LOGISTICS PARK KANSAS CITY (LPKC) SOUTH, FOURTH PLAT

Application FS2022-01

FINAL SITE PLAN REVIEW

Staff has reviewed the Final Site Plan submittal for compliance with the requirements in Section 10.1 of Article 10 and Section 5.2 of Article 5 of the Edgerton Unified Development Code (UDC). Review comments are as follows:

3 OVERALL EAST ELEVATION
Scale: 1/8"

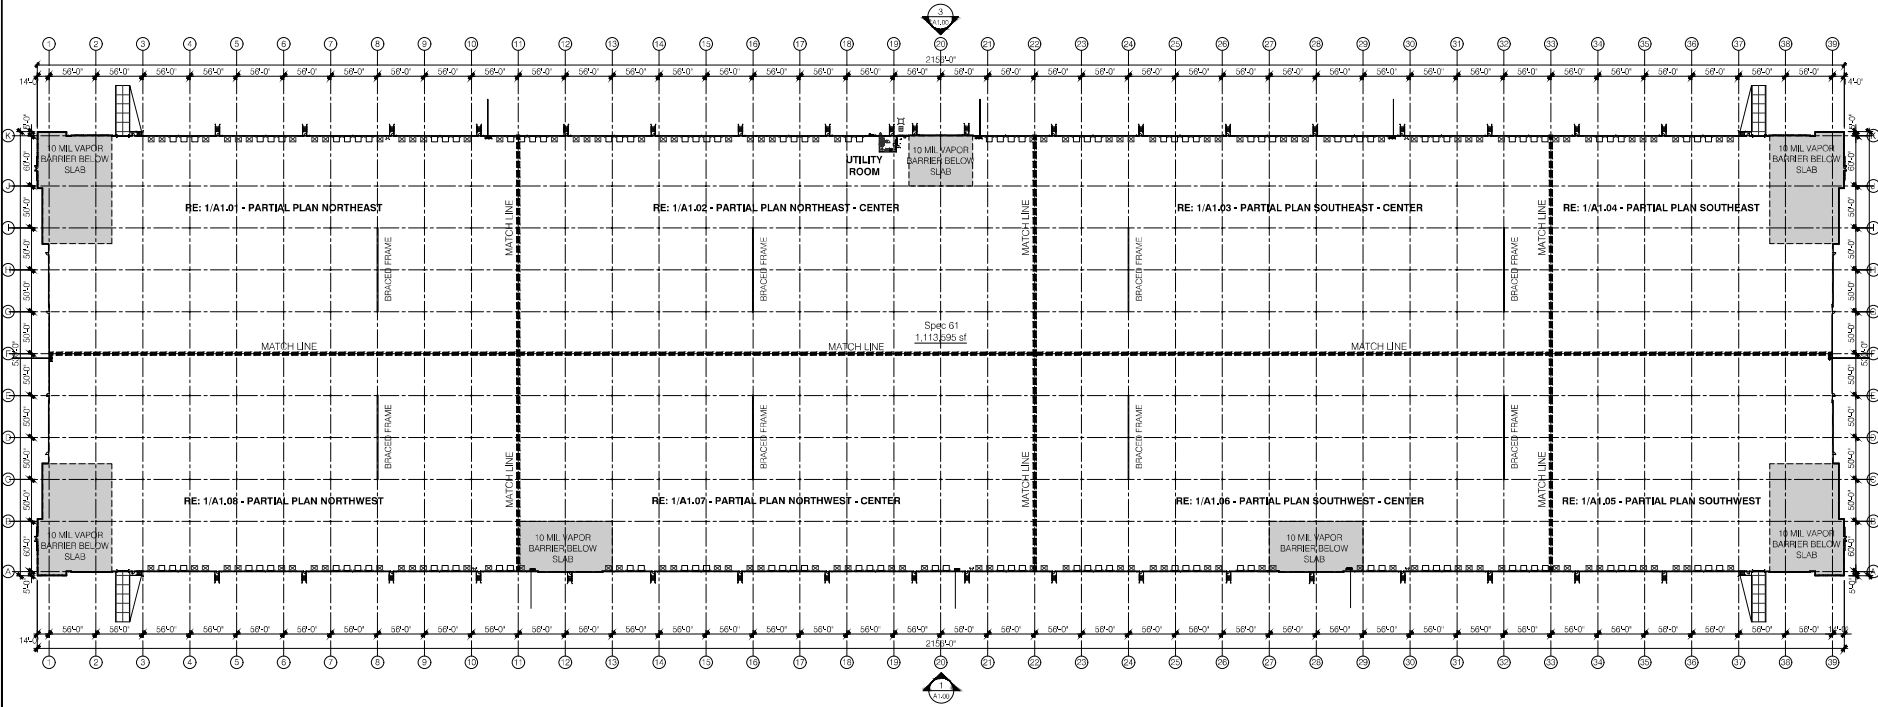
i. Three (3) façades of each building are adjacent to public right-of-way or residentially zoned property. On the east and west façades of the buildings, there are a series of dock doors. Based upon the building measurements, the UDC requires an offset of 4.575 feet (10% of the average wall height of 45.75 feet) after a distance of 183 feet (the first plane calculated at four (4) times the average wall height). Per the calculation method outlined above, this offset should extend for 36.6 feet (20% of the 183-foot first plane).

ii. The east façade of Inland Port 62 and the west façade of Inland Port 61 have additional horizontal articulation at the mid-entry points due to the building's adjacency to residentially zoned parcels. On the east and west façades of each building, the applicant has provided two sections of five (5) foot changes in depth after spans of thirty-five (35) feet at each corner of the building. These changes in depth at the corners meet the required calculations outlined in the UDC.

iii. Due to the length of these warehouse facades, the applicant has used paint color changes and the addition of two mid-point entry ways on the facades that are adjacent to residential property to contribute to horizontal articulation.

- i. *Three (3) façades of each building are adjacent to public right-of-way or residentially zoned property. On the east and west façades of the buildings, there are a series of dock doors. The applicant should provide an offset of 4.575 feet (10% of the average wall height of 45.75 feet) after a distance of 183 feet (the first plane calculated at four (4) times the average wall height).*

- ii. *On the east and west façades of each building, the applicant has provided a change in height of two (2) feet that spans twenty-six (26) feet for every seventy-eight (78) feet of horizontal wall. At the mid-entry, an additional four (4) feet of vertical change occurs that spans for seventy-eight (78) feet.*

- iii. *The applicant has used changes in paint color, the addition of two mid-point entry ways on the façades that are adjacent to residential property, and more frequent, smaller changes in height to contribute to vertical articulation.*

City staff feels the articulation provided coupled with the changes in paint colors meets the spirit and intent of the code and recommends approval of this deviation.

City staff feels the articulation provided coupled with the changes in paint colors meets the spirit and intent of the code and recommends approval of this deviation.

SIGHT LINE CC - 3 years growth

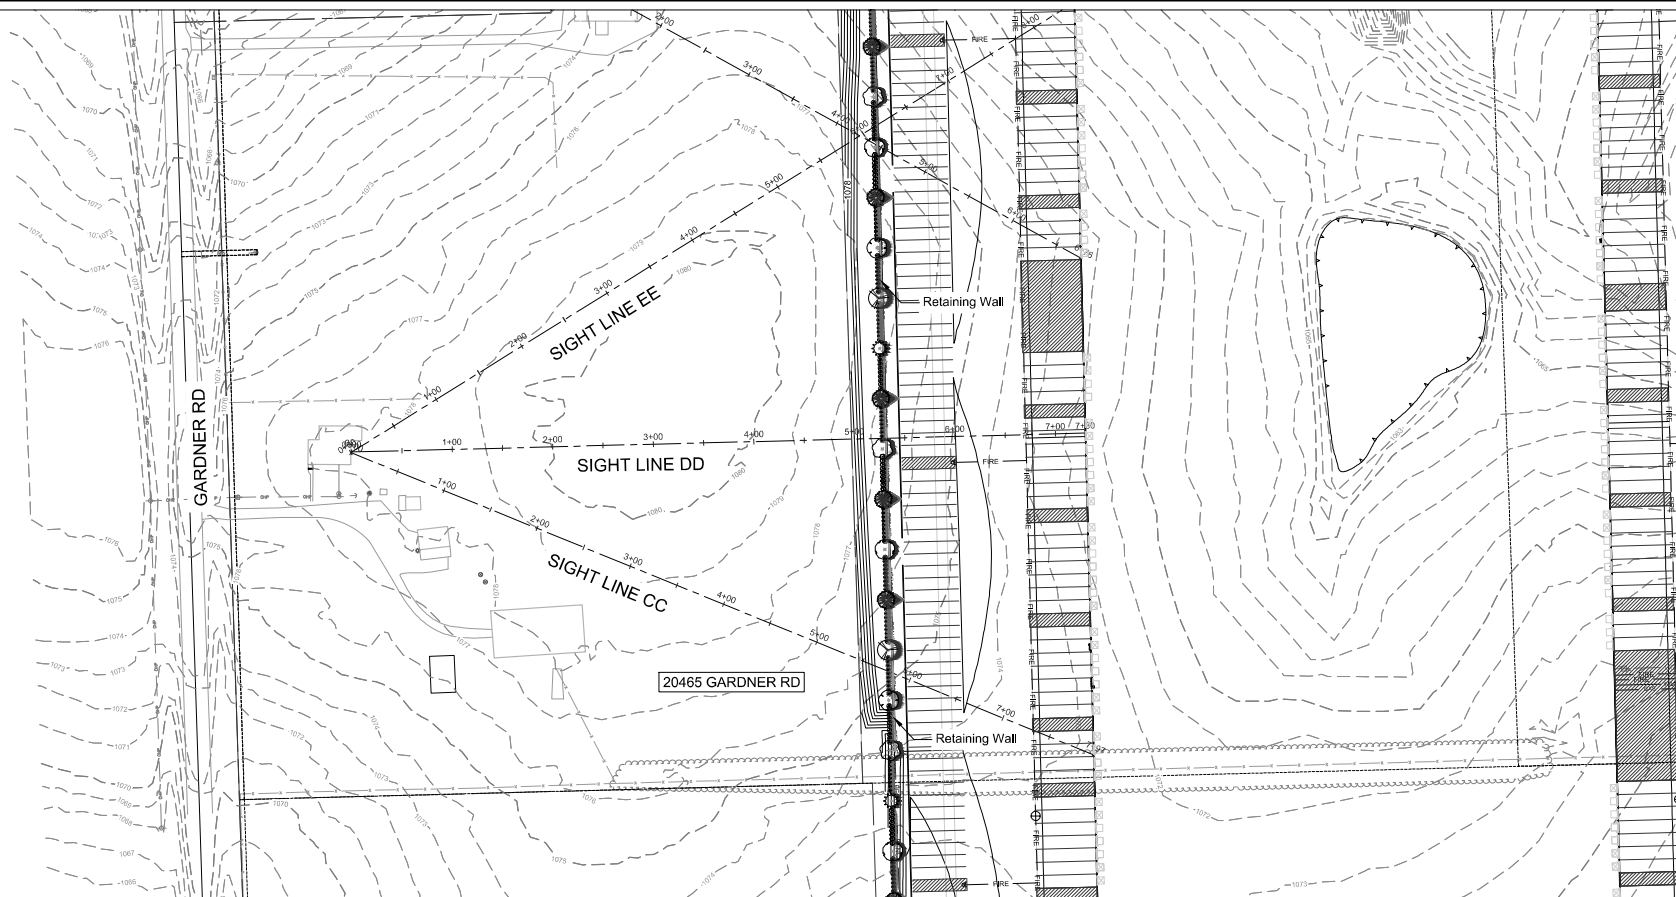
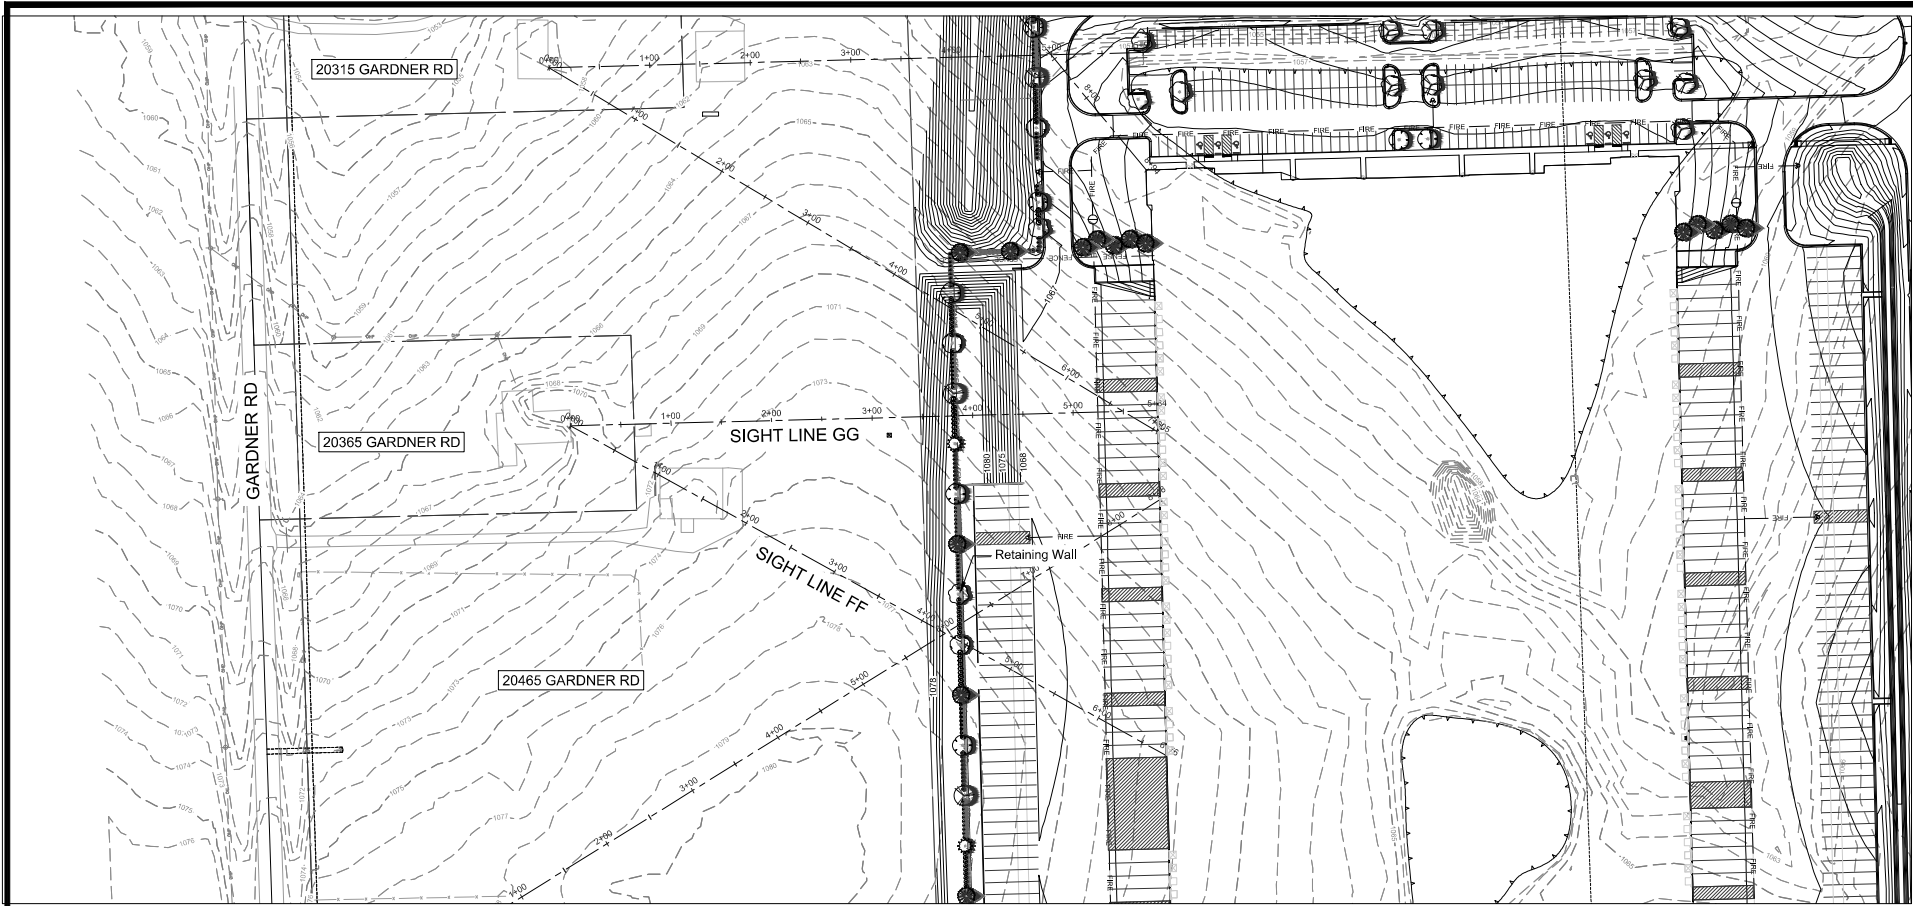
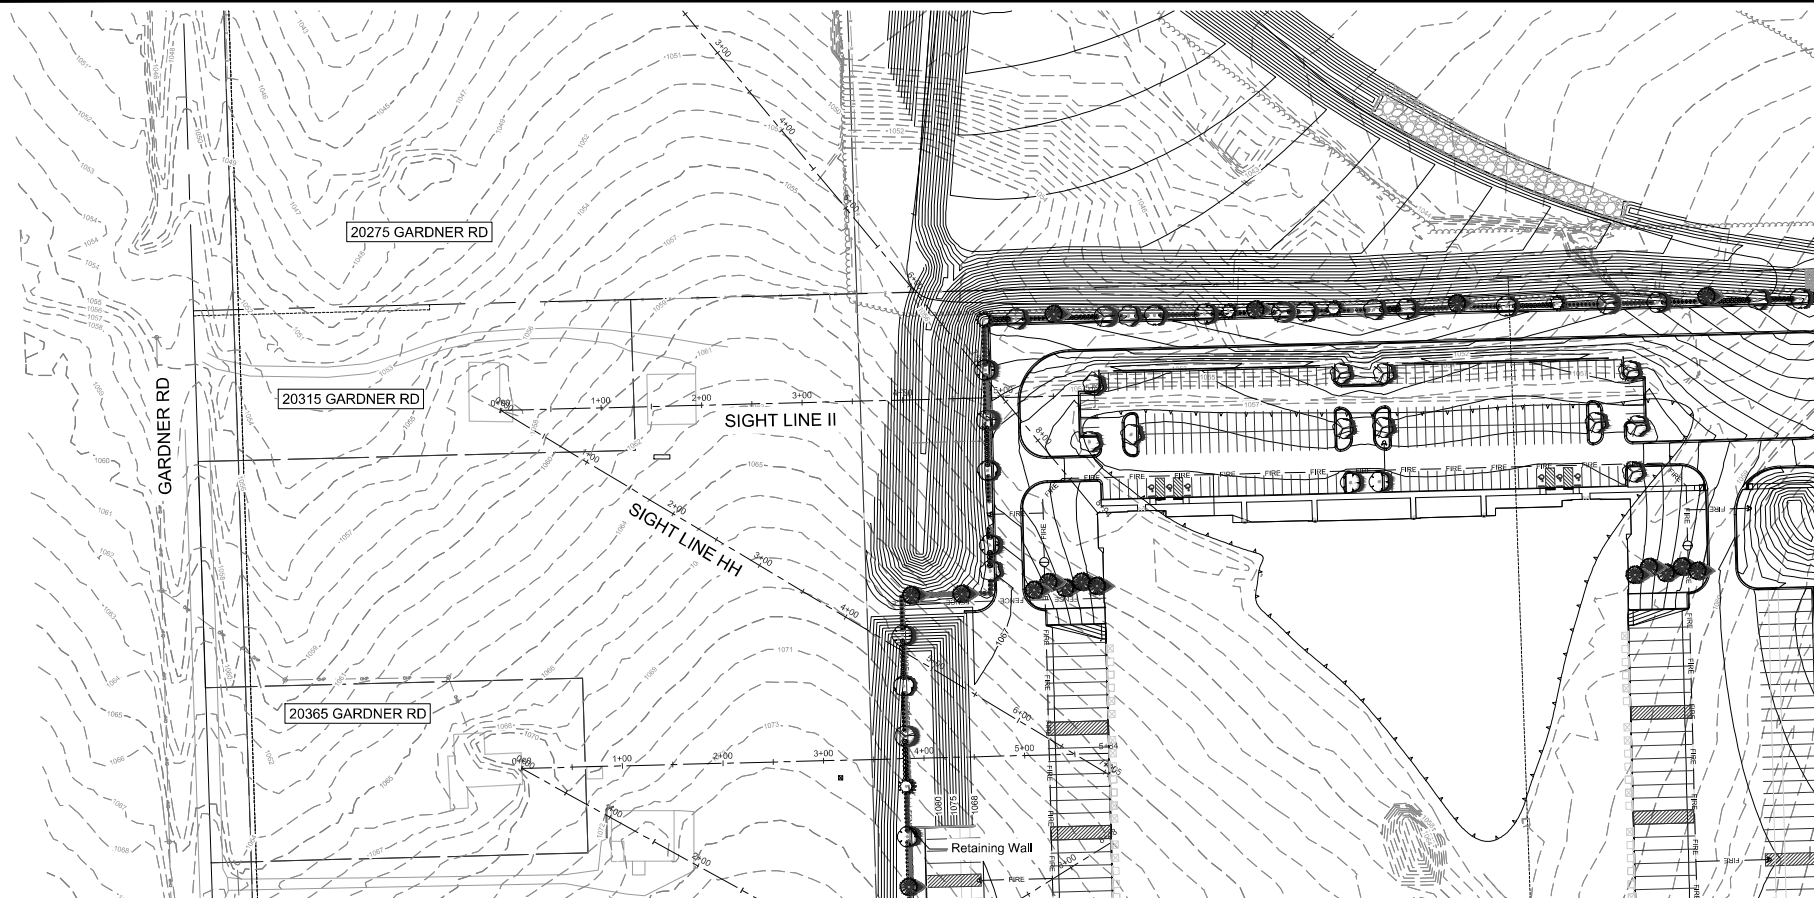
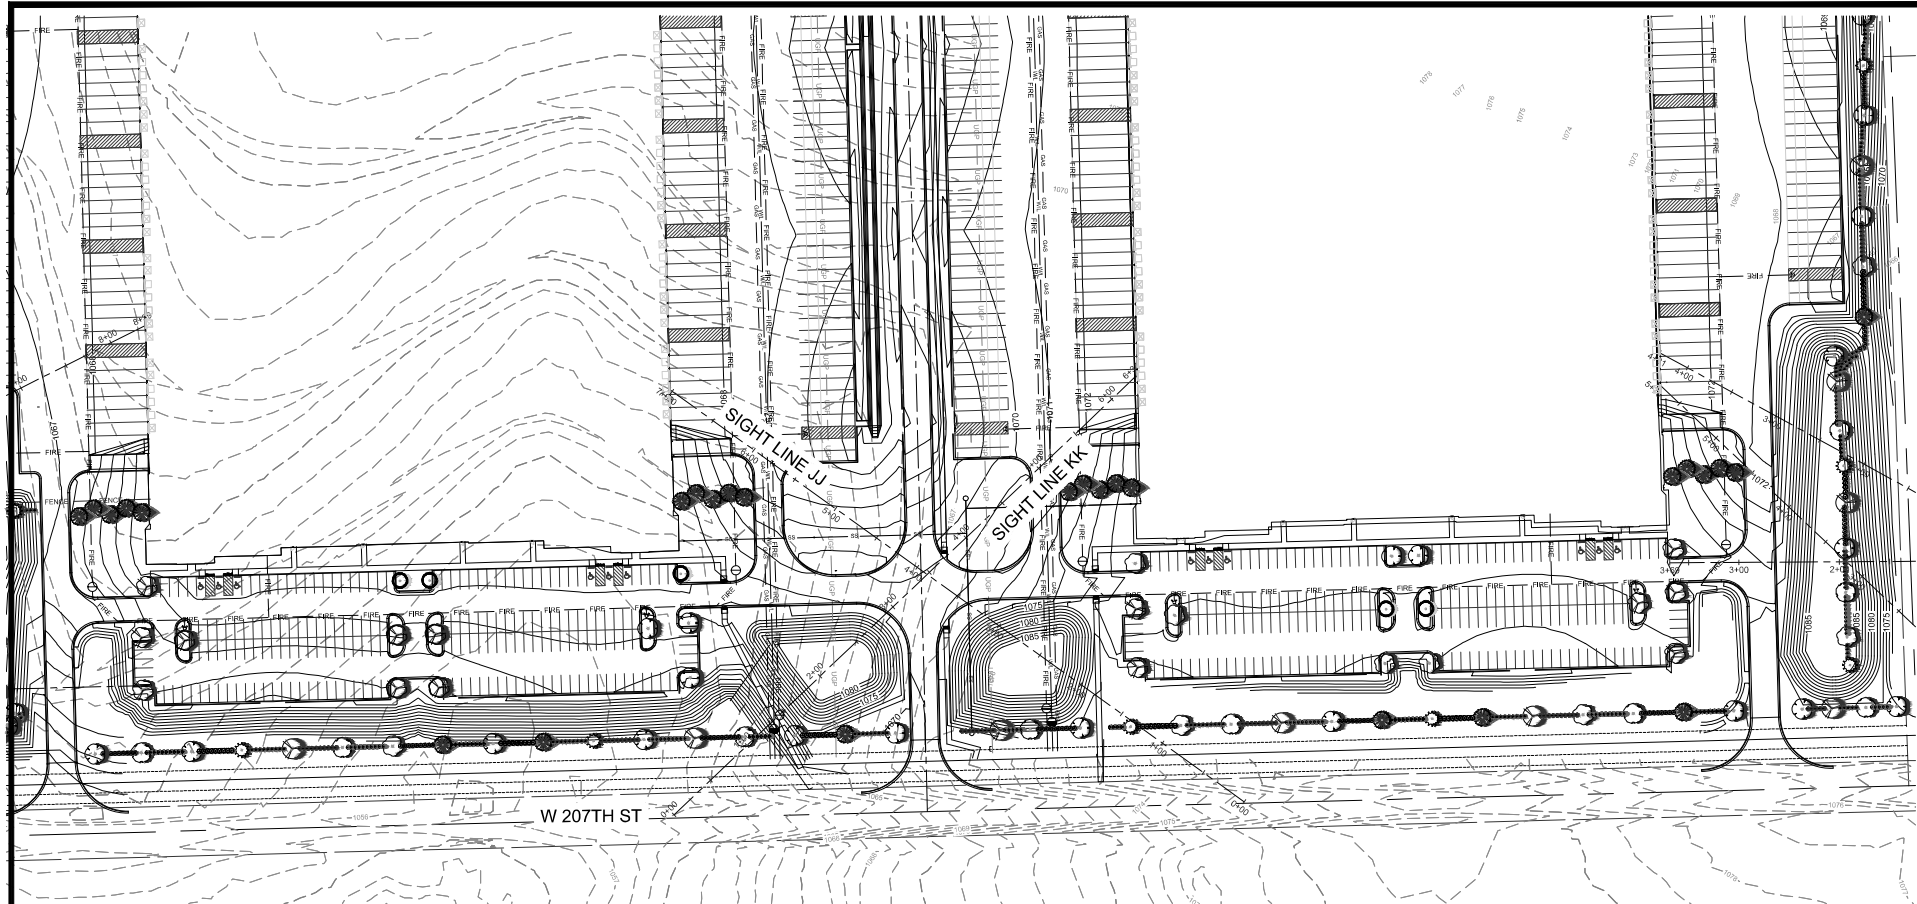
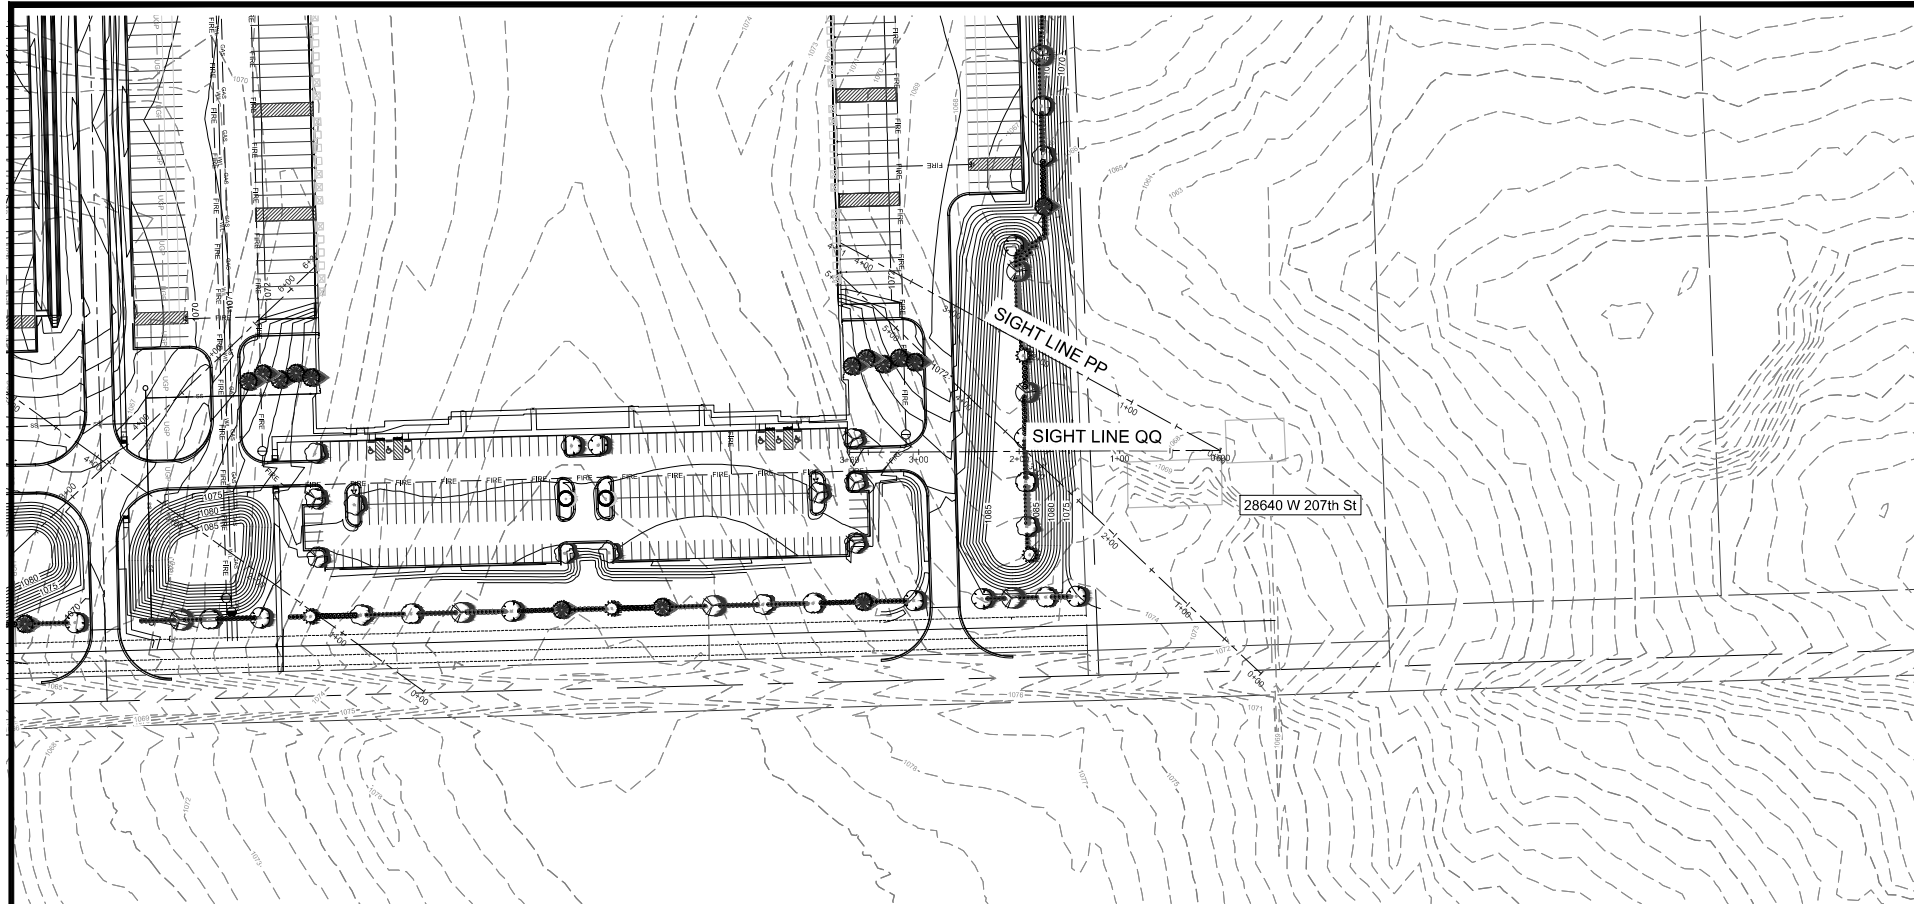
1. A data table which, at a minimum, includes: acreage of the site and number of units per acre (if applicable), gross square feet of the building(s) area, the proposed use of each building, number of employees and the total number of parking spaces to be provided.
 - a. *Several parking stalls were removed to add additional berming and landscaping on the west side of the project site. The submitted Final Site Plan does not reflect the changes shown in the Line of Sight drawings submitted for the project.*

- i. *The applicant has provided Line of Sight Drawings showing the screening of the trucks and chassis from multiple vantage points from neighboring properties. All landscaping and berms must be maintained to ensure this requirement is met at all times.*
- ii. *The applicant has included a vinyl shadow box fence to be used along the east side of the property to ensure effective screening is accomplished. All fencing must be maintained to ensure this requirement is met at all times.*

Update Final Site Plan to match the Line of Sight Drawings.

Applicant acknowledges.
